APPLICATION NO.	FILING DATE	FIRST NAMED INVENTOR	ATTORNEY DOCKET NO.	CONFIRMATION NO.
09/865,514	05/29/2001	Kazuma Okuda	010568	3133

Office Action Summary

The following title is suggested: Outer rotor type motor/generator with an air inlet passage and air gap shield coverings on stator.

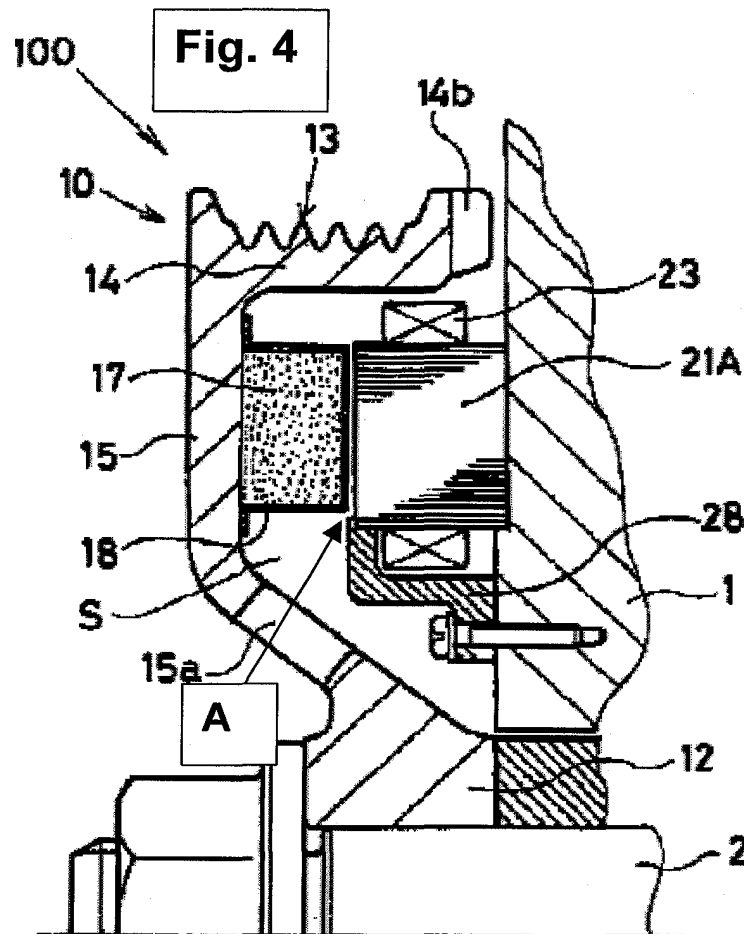
Kusase et al. illustrates a generator motor (100) in Figure 1, that is positioned between a pulley (10) and an engine housing (1) with a pulley (10) fitted over an end part of a crank shaft (2) with the stator yoke (21) positioned to the protruding wall (20) of the engine housing (1). Furthermore, a rotor yoke (16) is secured fixedly on to the inner peripheral face end (14) of the pulley (10), with the rotor yoke (16) facing the stator yoke (21) diagonally from an air gap (A). Additionally, Figure 1 illustrates an air passage (B) that is positioned between engine housing (1) and the peripheral wall edge (C) of the pulley (10). In addition, Kusase et al. illustrates in Figure 4 a recessed space (S). However, Kusase et al. does not illustrate a crank pulley with fan blades positioned on to the side walls at are extending radially outward from an end of the crank shaft and stator coils cooled from air flowing through the annular space by way of the air passage with the air being discharged through the fan blades.

第 3 図

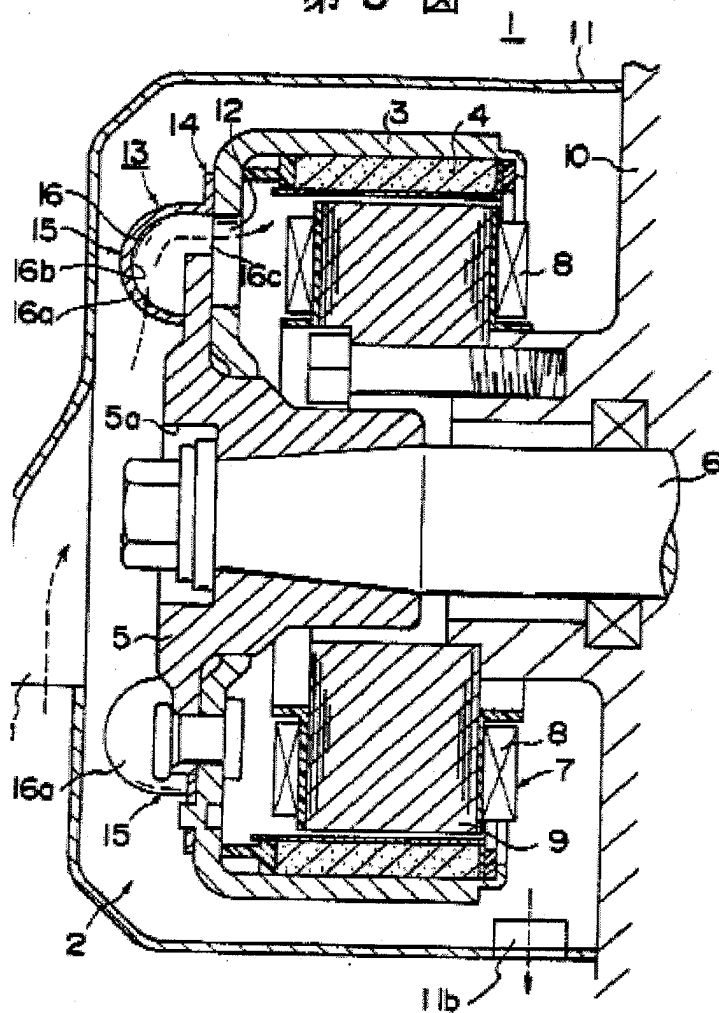
Yoda et al. illustrates in Figure 3 a generator with fan blades (15) that radially extend outward from the crankshaft (6) and are positioned onto the body (14) of the fan (13) that is located on to a crank pulley (5).

第 4 圖

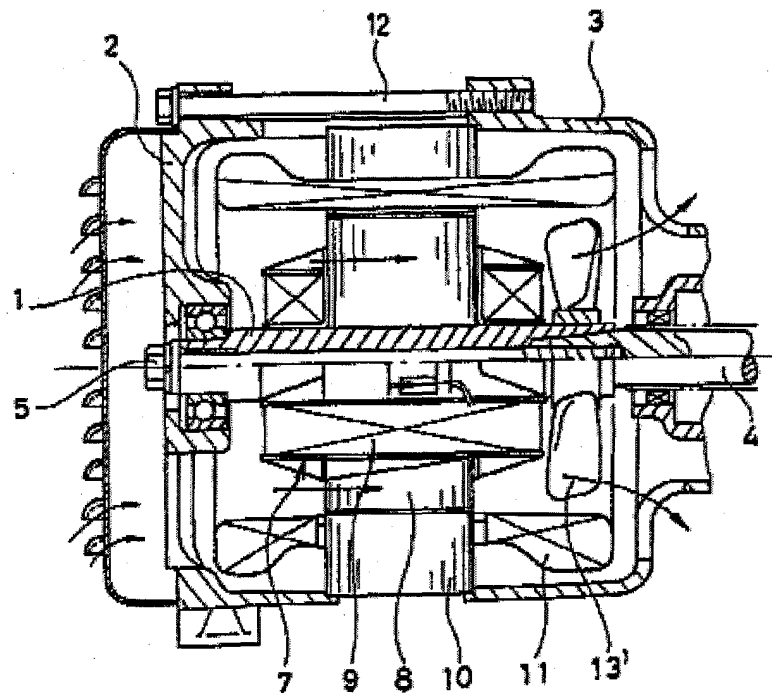
It illustrates in Figure 4 a generator in which air flows through a stator core (8) with coils (11) and is discharged through the fan blades (13') to the outside of the generator.

FIG.2

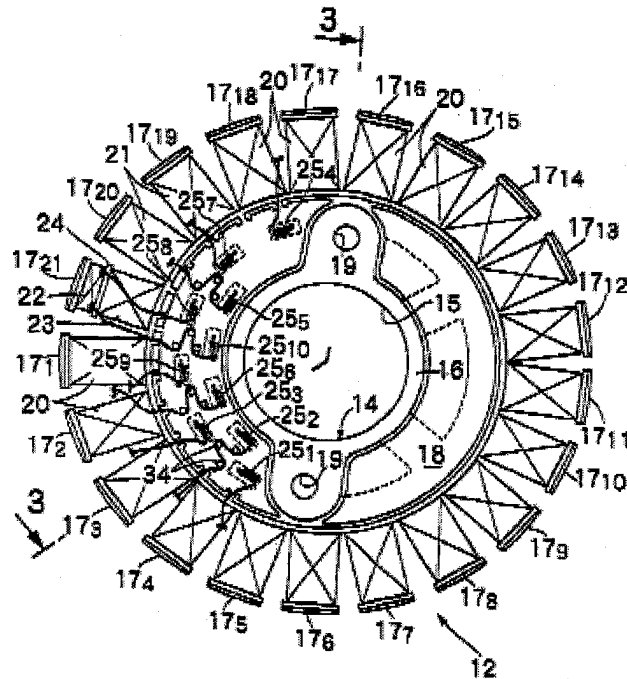
Kusase et al. and Yoda et al. and Ito and Gritter et al. teach all of claims 1 and 2 except for the plurality of the stator core and coils with the coils wound around the cores and projecting in a circumferential direction. Kakinuma et al. discloses in Figure 2 a stator (12) with stator cores (14) formed from a plurality of core plates with coils (20) and formed into a T-shape and projectingly provided from a distance apart from one another. However, Kakinuma et al fails to show cores with coils wound around the cores and an air passages between the coils.

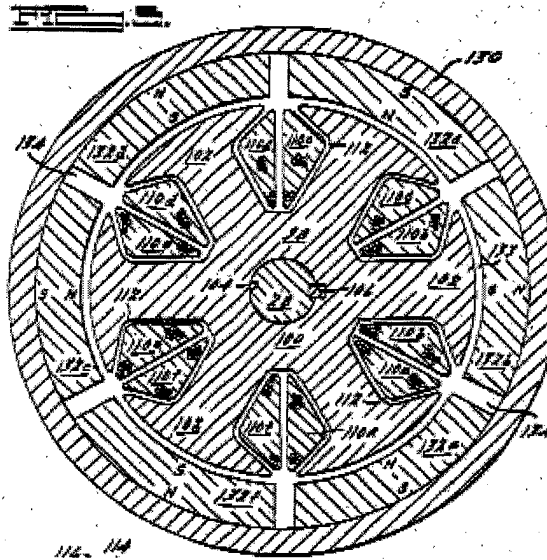
Gritter et al. illustrates in Figure 5 a stator assembly in which the coils (110) are wound around each armature tooth (102) and are extrapolative in a circumferential direction with an air passage (A) between the coils (110a through 110f).

It would have been obvious at the time the invention was made to a person having ordinary skill in the art to modify Kakinuma et al.'s invention by adding an air passage (A) between the coils to lower initial and manufacturing cost, reduce weight, and reduce substantial amounts of volatile liquid fuels and exhaust emissions.

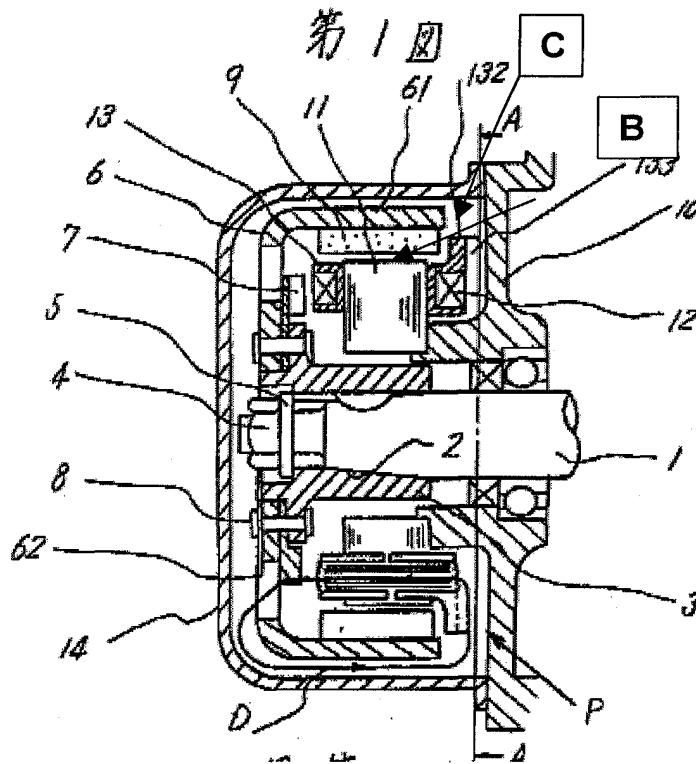
the outer periphery of the stator. Kamiyama illustrates in Figure 1 a generator in which a guide fin (133) acting as a cover for the air gap (A) is projecting from the upper end of the stator coil (12) facing an air inlet passage (B) for effective cooling of the coils.

It would have been obvious at the time the invention was made to a person having ordinary skill in the art to modify Kakinuma et al.'s invention by adding a guide fin (133) projecting from the top edge of the stator coil (12) in order to efficiently circulate the cooling air for guiding fluid in order to effectively cool the coils (12).
